# FITZSIMONS GATEWAY MULTIFAMILY | SITE PLAN

LOT 2, BLOCK 1 FITZSIMONS PROMENADE SUBDIVISION FILING NO. 1 AMENDMENT 1  
 LOCATED IN THE NORTHWEST 1/4 OF SECTION 1, TOWNSHIP 4 SOUTH, RANGE 67 WEST OF THE 6TH P.M.,  
 CITY OF AURORA, COUNTY OF ARAPAHOE, STATE OF COLORADO

## AMENDMENTS

DATE:  
 08/24/22 - SITE PLAN 01  
 10/17/22 - SITE PLAN 02  
 11/23/22 - SITE PLAN 03  
 12/19/22 - SITE PLAN 04  
 02/13/23 - SITE PLAN 05  
 05/17/23 - MINOR AMD 01-1  
 12/08/23 - MINOR AMD 01-2  
 01/30/24 - MINOR AMD 01-3

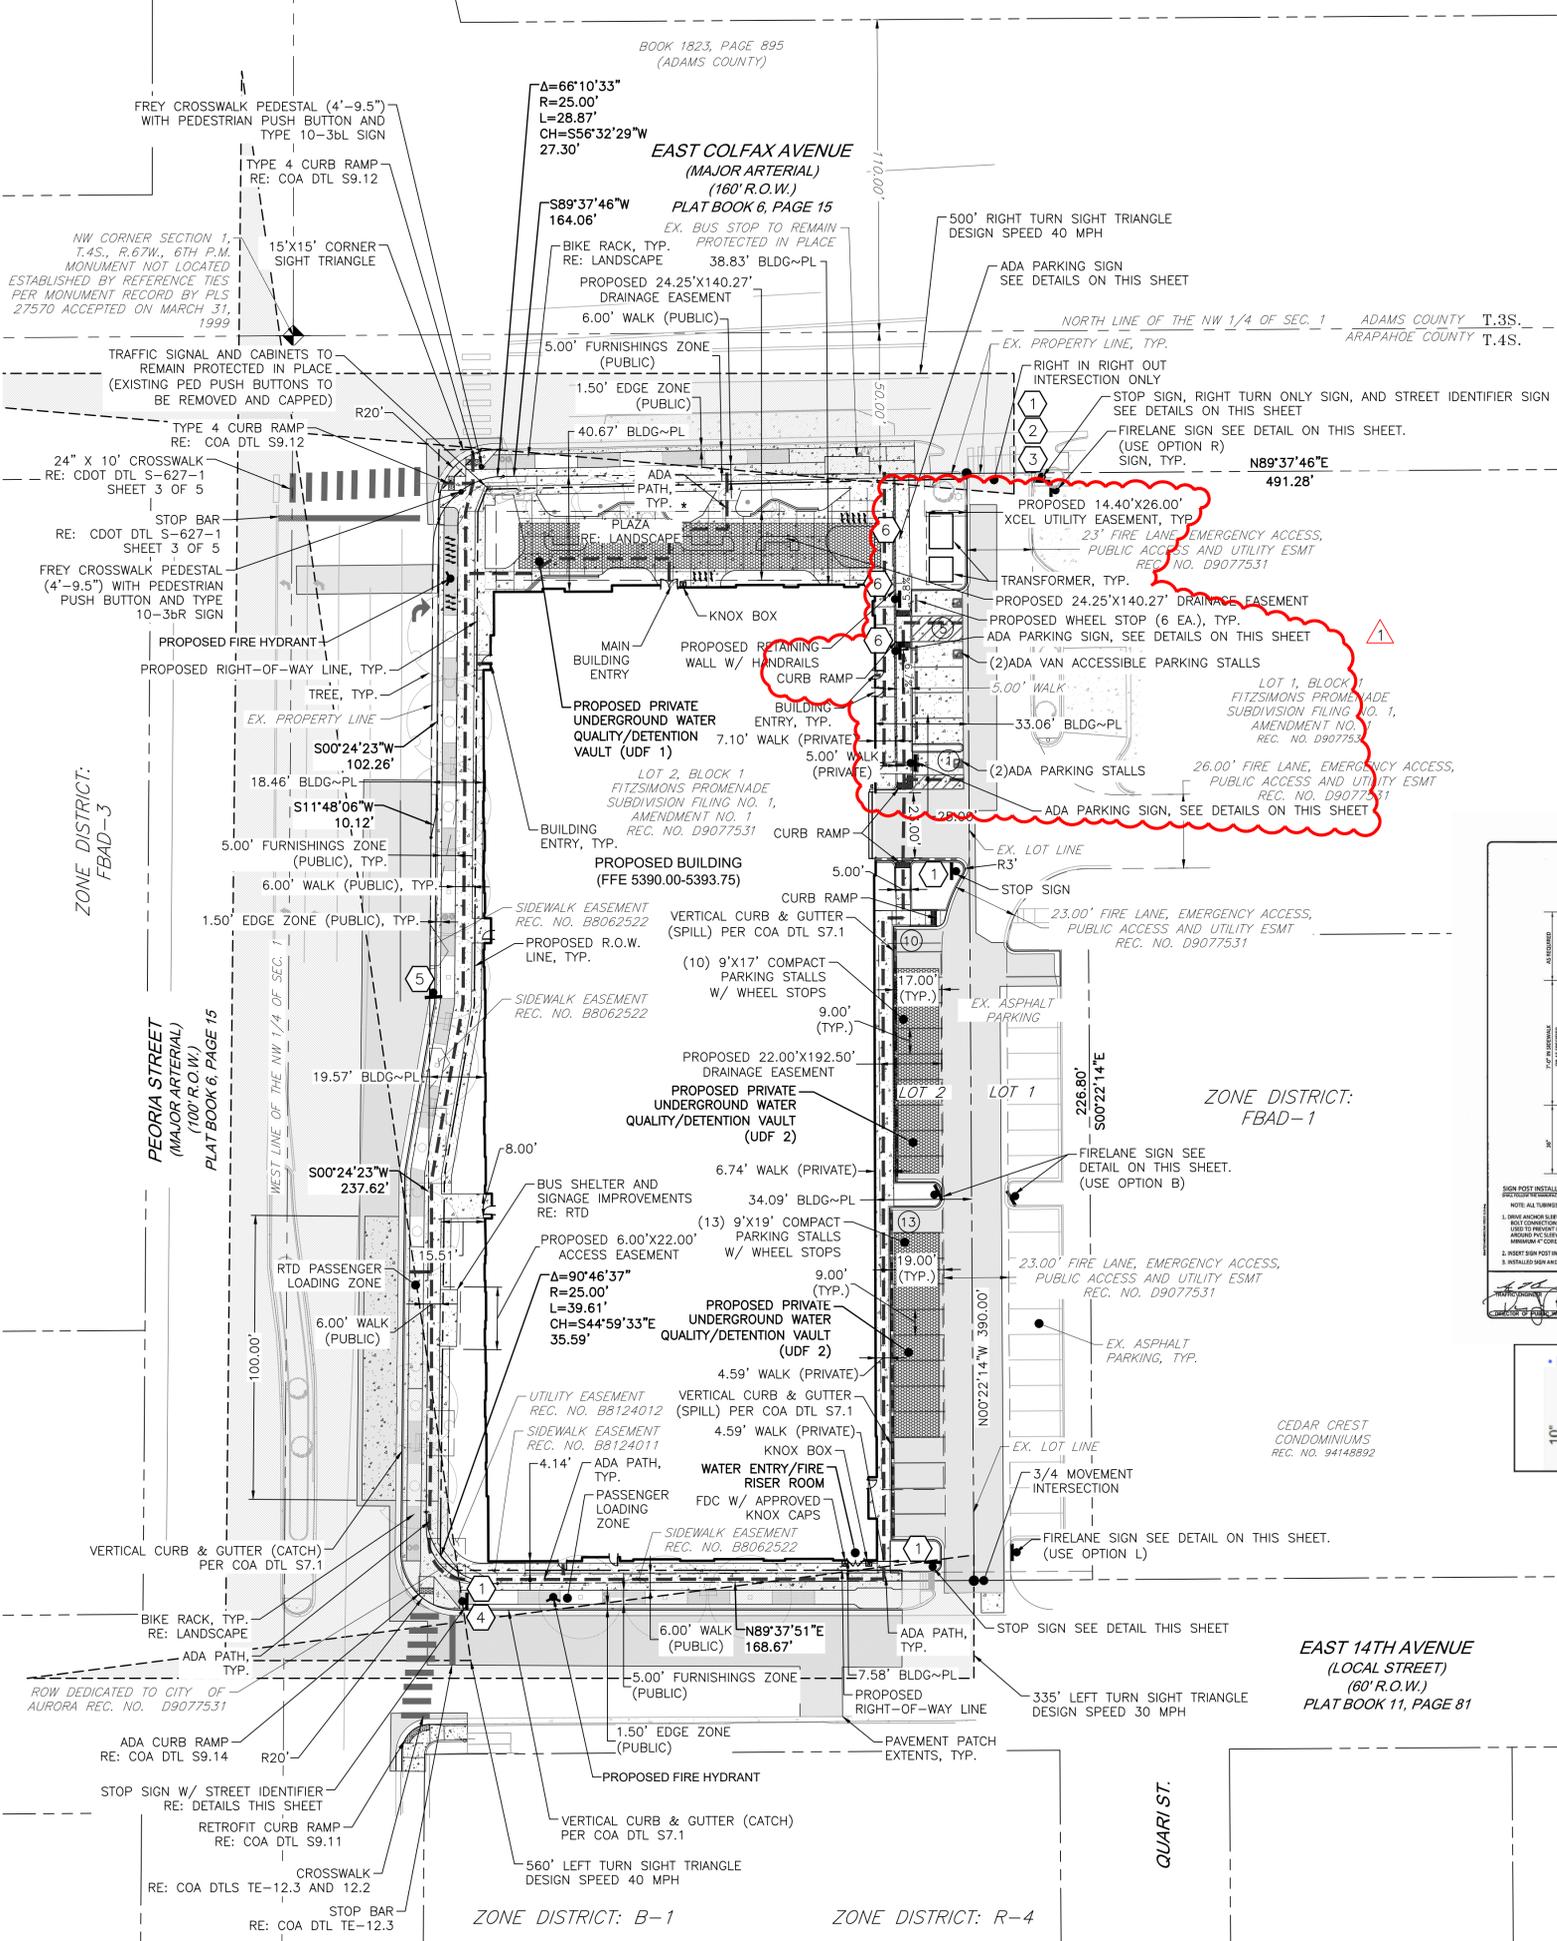
- 12/08/2023 MA: 2022-4047-01
  - TRANSFORMERS HAVE BEEN RELOCATED TO THE NORTH TO AVOID CONFLICT WITH STORMLINE AT PRIOR LOCATION; PARKING HAS BEEN RELOCATED TO THE SOUTH WITH NO CHANGES TO NUMBER OF STANDARD OR ACCESSIBLE SPACES. UPDATES SHOWN ON SITE PLAN, UTILITY & GRADING PLAN, HARDSCAPE PLAN, LANDSCAPE PLAN, LANDSCAPE ENLARGEMENTS, AND OVERALL PHOTOMETRIC PLAN.

- CURB RAMPS ADDED TO SITE PLAN SHEET TO SHOW ACCESSIBLE TRANSITION FROM ACCESSIBLE PARKING SPACES TO SIDEWALK ON THE EAST SIDE OF THE BUILDING. UPDATES SHOWN ON SITE PLAN, UTILITY & GRADING PLAN, HARDSCAPE PLAN, LANDSCAPE PLAN, LANDSCAPE ENLARGEMENTS, AND OVERALL PHOTOMETRIC PLAN.

**PLAZA LANDSCAPE ENLARGEMENT**

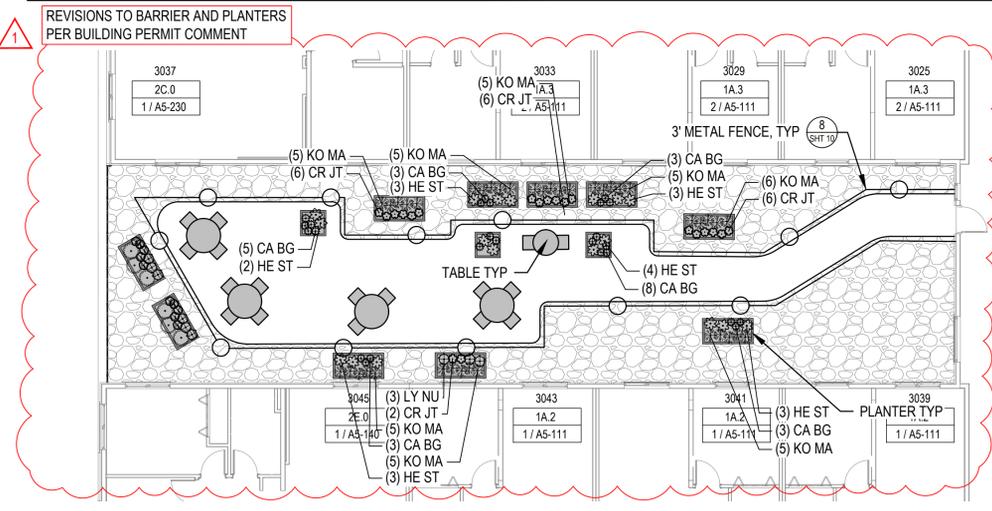
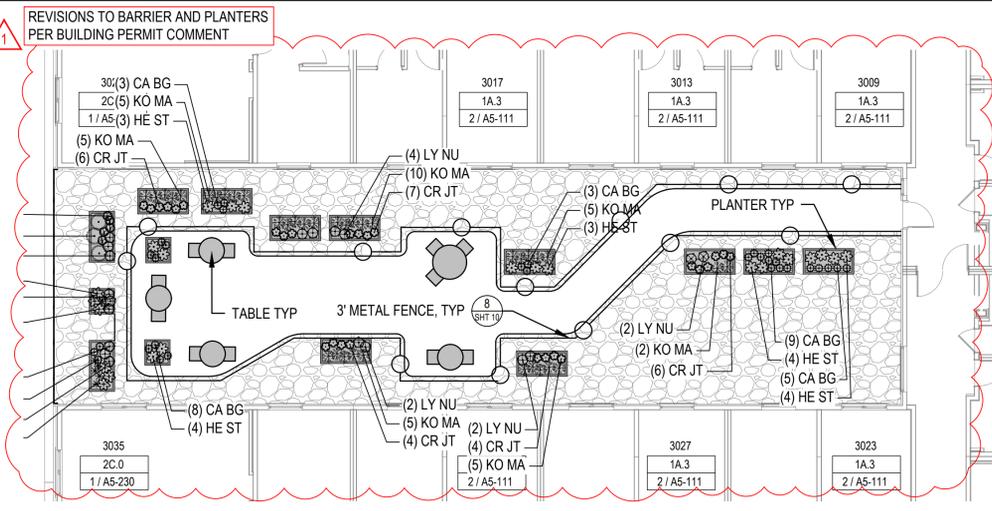
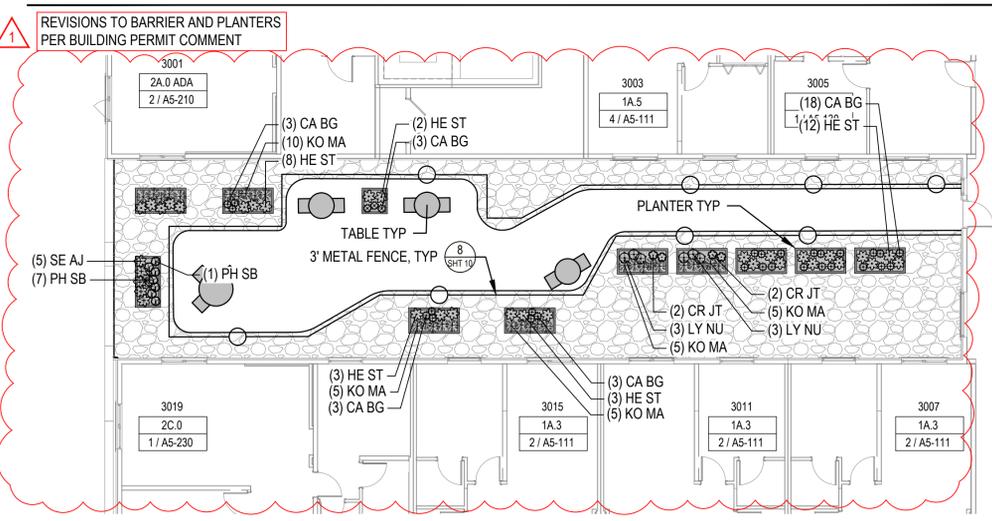
- AMENITY DECK LANDSCAPE PLANTERS AND FENCING REVISED PER COMMENTS RECEIVED DURING BUILDING PERMIT REVIEW. COBBLE REMOVED AND PLANTERS MOVED FURTHER FROM EDGE. FENCING DETAIL REVISED. UPDATES SHOWN ON LANDSCAPE ENLARGEMENTS, LANDSCAPE DETAILS, LEVEL 3 PHOTOMETRIC PLAN.

8 3' METAL FENCE

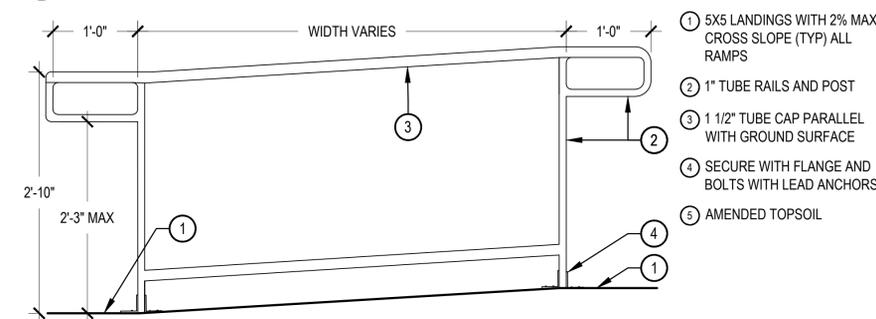
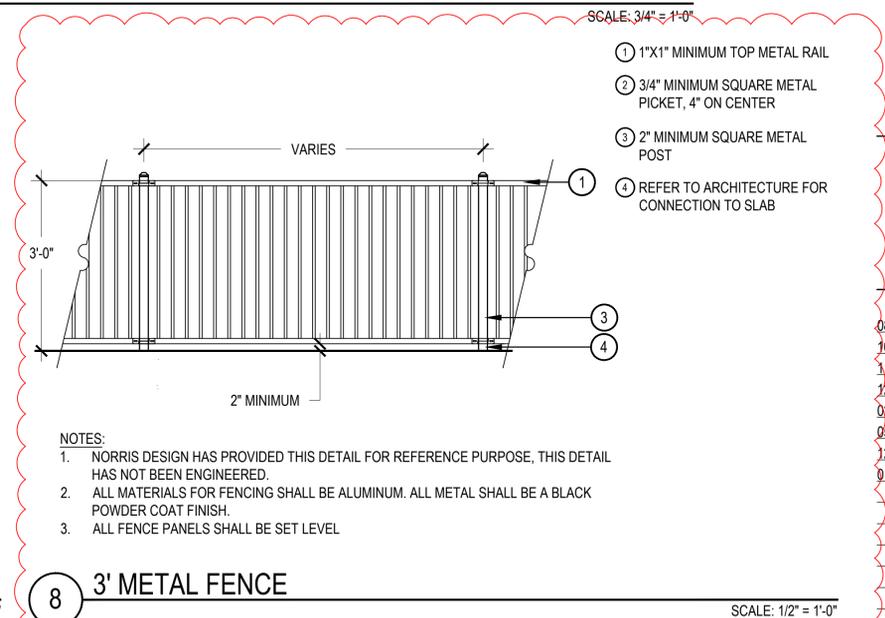
REVISIONS TO BARRIER AND PLANTERS PER BUILDING PERMIT COMMENT

**BUILDING ELEVATION - EAST**

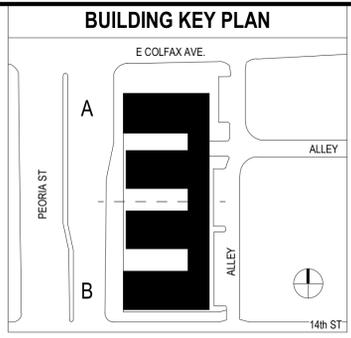
- PORTION OF MESH SCREENING ON EASTERN GARAGE ELEVATION HAS BEEN REMOVED TO PROVIDE INCREASED GARAGE VENTILATION AND REDUCED MESH MATERIAL AREA. UPDATE SHOWN ON EAST ELEVATION.

**1 SITE LIGHTING PHOTOMETRIC**  
SCALE: 1" = 30'-0"

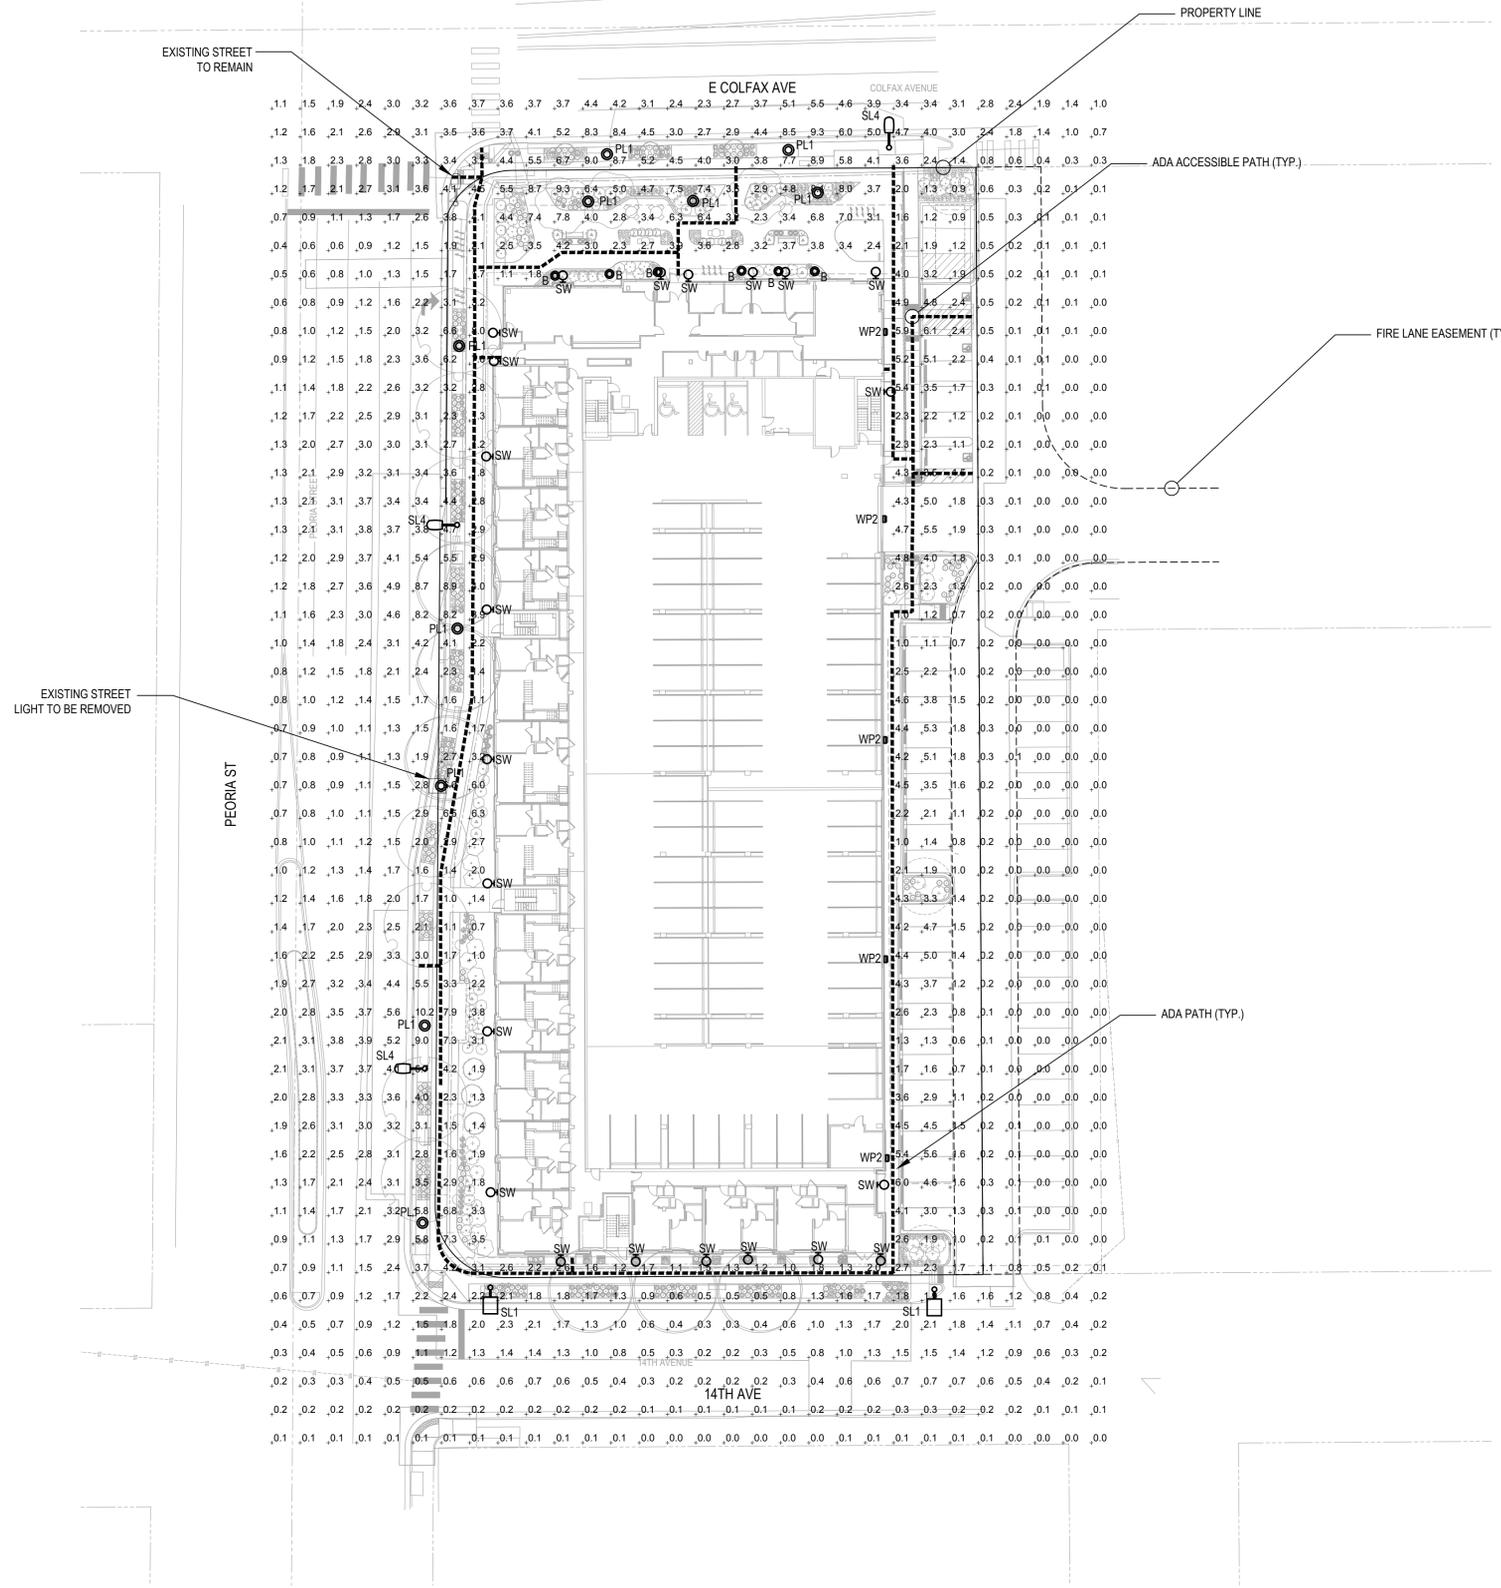
1 LIGHTING PLAN HAS NOT CHANGED, BUT UNDERLYING BASE DRAWINGS UPDATED TO REFLECT CHANGES WITH CIVIL AND LANDSCAPE DRAWINGS
